UNITED STATES PATENT AND TRADEMARK OFFICE

APPLICATION NO.	FILING DATE	FIRST NAMED INVENTOR	ATTORNEY DOCKET NO.	CONFIRMATION NO.
10/802,758	03/18/2004	Hitoshi Ito	02887.0268	5319

Office Action Summary

DETAILED ACTION

FIG. 6

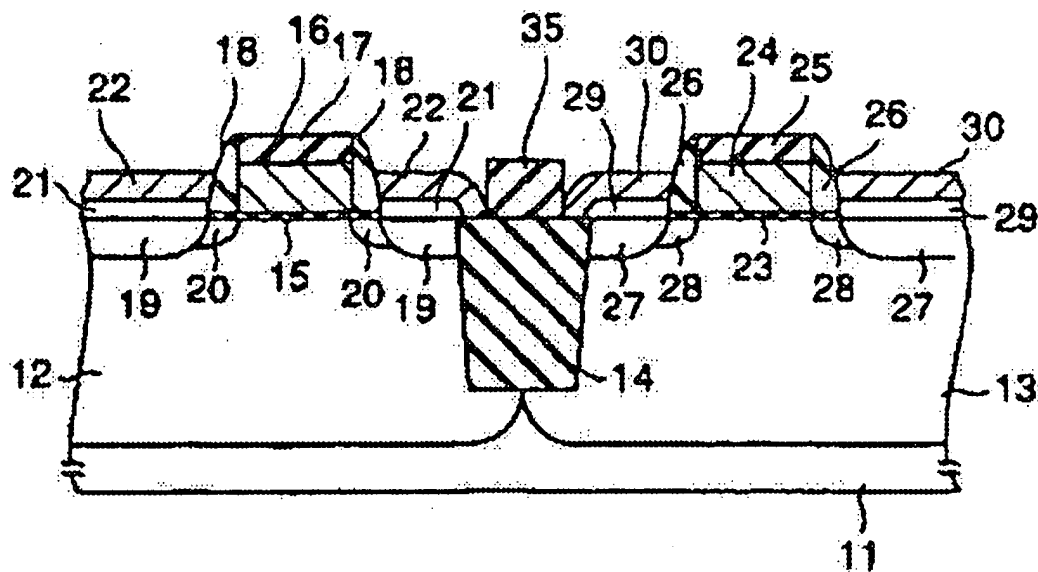
Regarding claim 1, Masato (Fig. 6) discloses a semiconductor device, comprising:

a semiconductor substrate 11 (paragraph [0118], lines 1-2);

a source region 19, which is formed in a surface side of the semiconductor substrate 11 (paragraph [0122]);

a drain region 19 that is formed in the surface side of the semiconductor substrate 11, which is apart from the source region (see Fig. 6 Labeled by the examiner below and paragraph [0122]);

a gate electrode 16 that is formed on the semiconductor substrate via a gate insulating film 15 and which is between the source/drain regions 19 (paragraph [0120], lines 1-2);

a stopper 35 which is formed of a SiN material (paragraph [0163]) different from a SiO material of the element isolation insulator 14 (paragraph [0021]) and which is at a predetermined distance from the semiconductor substrate 11 so as to protrude from the surface of the element isolation insulator 14; and

an elevated source/drain 21 which is formed on the source / drain regions 19 so as to be elevated from the surface of the semiconductor substrate 11 (see Fig. 4 and paragraph [0141]).

FIG. 13

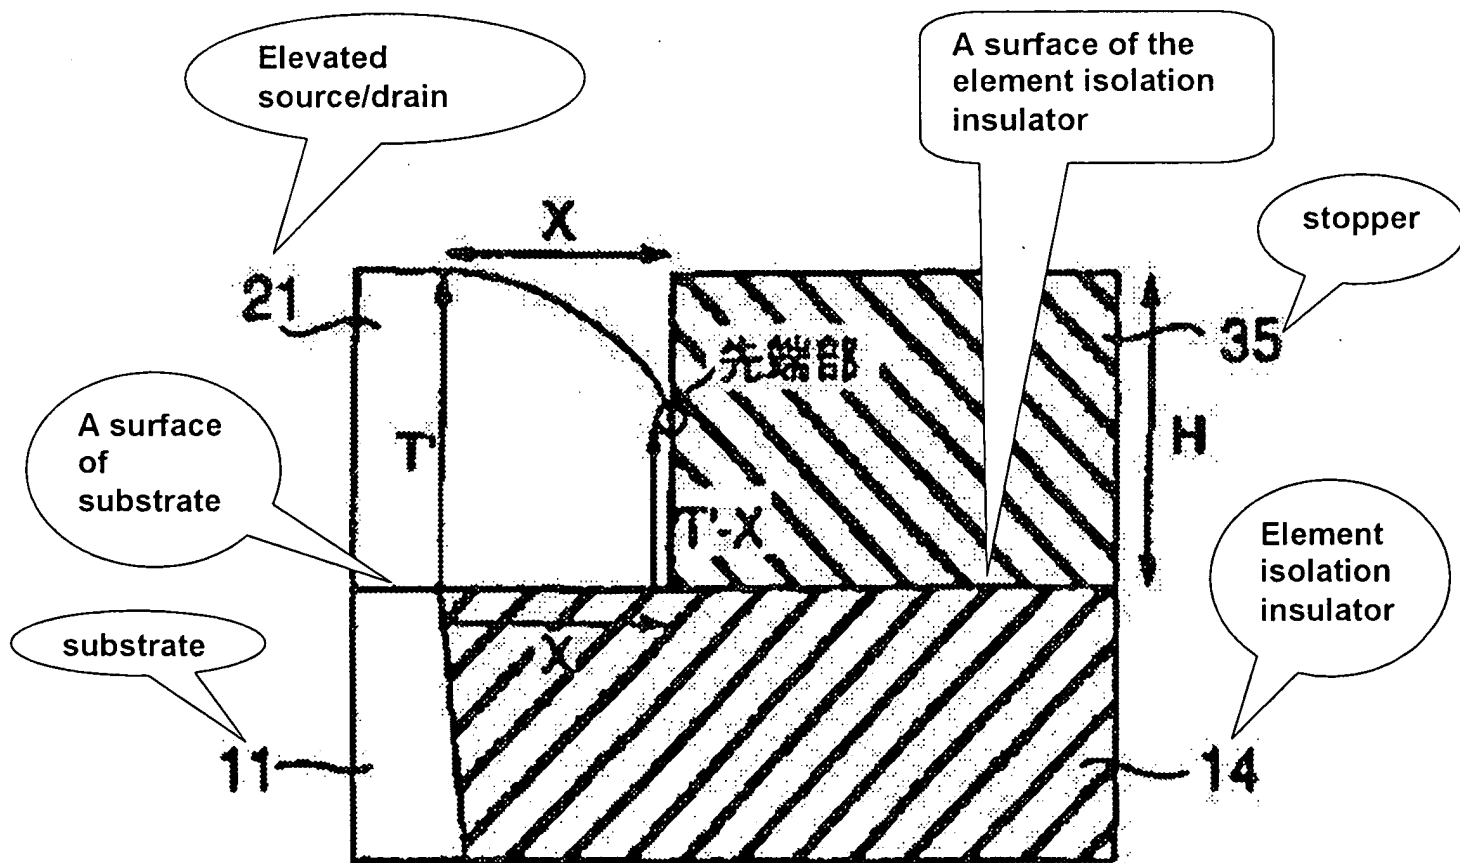
an element isolation insulator 14 which is formed on the surface side of the semiconductor substrate 11 to provide electrical insulation from other elements, a height of a surface of the element isolation insulator 14 being equal to a surface of the semiconductor substrate 11 (see Fig. 13 Labeled by the examiner below and paragraphs [0118], lines 2-4 and [0143], lines 1-3);

Regarding claim 5, Masato discloses that a facet appears in the elevated source/drain 21, the elevated source/drain grows in a vertical direction after it touches the stopper 35 (see Fig. 13 above).
